Brisbane Central Business District Bicycle User Group

This submission conveys the views of the Brisbane Central Business District Bicycle User Group (CBD BUG) on the proposed redevelopment of Victoria Park outlined in BCC's Victoria Park Draft Master Plan document. Figures __, __ and __ referred to within this submission are provided at the end of this document.

Figure 3

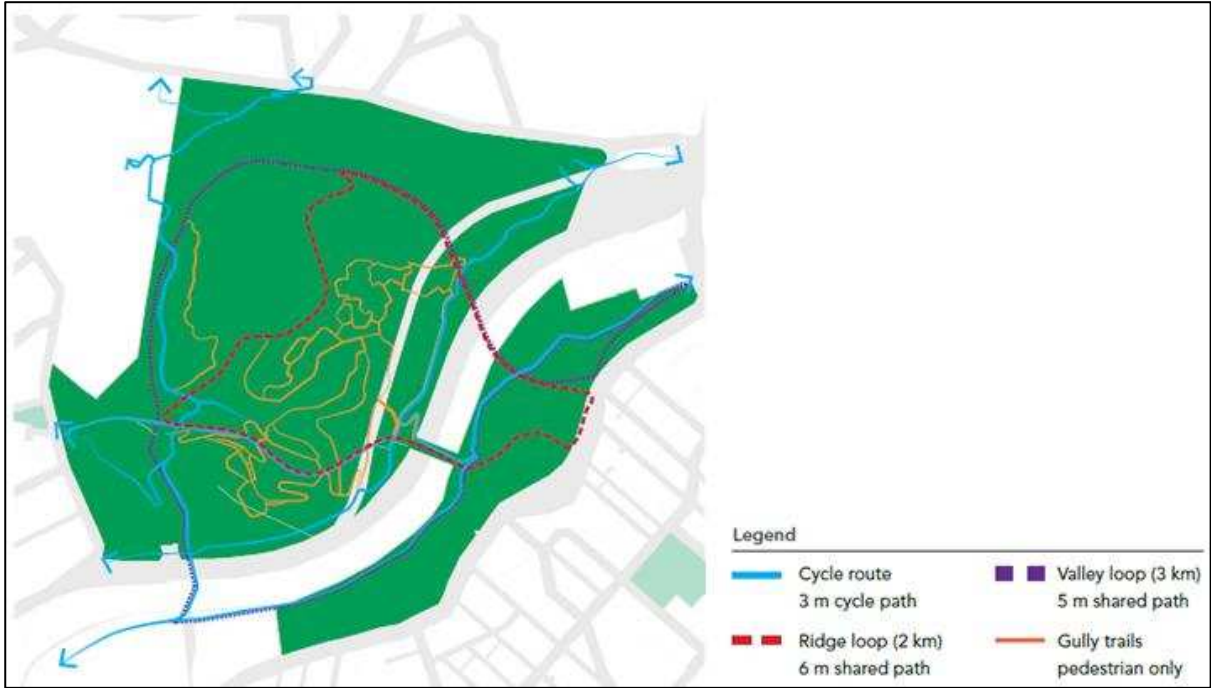
It is pleasing to see the draft master plan continues to list "primary active transport routes" as being provided with "dedicated separate cycle route". However, we are concerned reference to a "3m cycle path" has been now omitted. (Figure 1,2&3). This is concerning to the CBD BUG as it means there is no level of quality of the active transport conveyed. The previous vision document indicated that the paths were to be dedicated/segregated paths allowing for high volumes ensuring safety and amenity for all. We continue to advise that 3m should be a bare minimum and 3.5 to 4m would be more suitable for dedicated cycle paths to avoid future upgrading works.

It is extremely disappointing that a dedicated/segregated active transport corridor is not being provided over the land bridge. Dedicated paths were originally shown in the vision document but these have now been removed. Not providing dedicated paths would mean non-compliance with “AustRoads – Part 6A, Pedestrian & Cyclist Paths” (Figure 6).

Accordingly, we call for this dedicated/segregated active transport corridor to be reinstated in the plan.

Figure 5

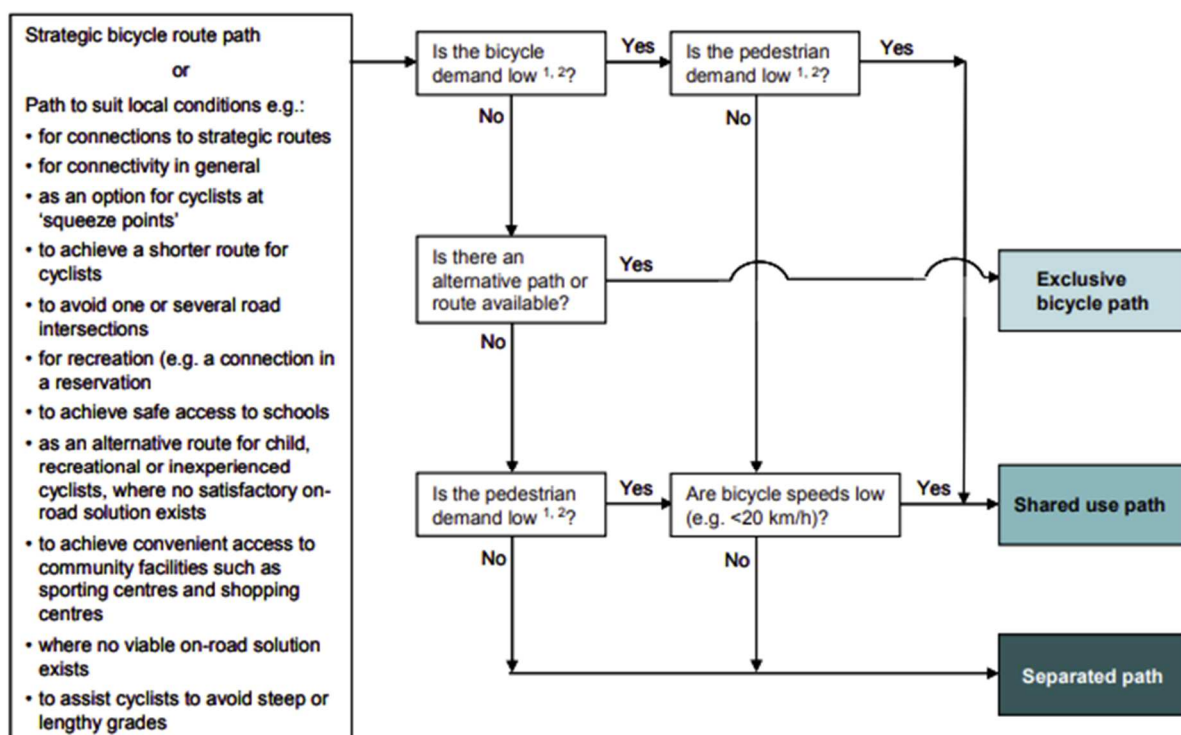
The realignment of the NBB paralleling the ICB is a welcome improvement that will save travel time for people accessing the suburbs of Albion, Woolloowin and further north. It is pleasing that the unnecessary bends in the previous vision document have now been removed in line with the principals of “AustRoads – Part 6A, Pedestrian & Cyclist Paths” where it clearly states - “Sharp curves should not be used to achieve landscaping objectives” (Figure 5).
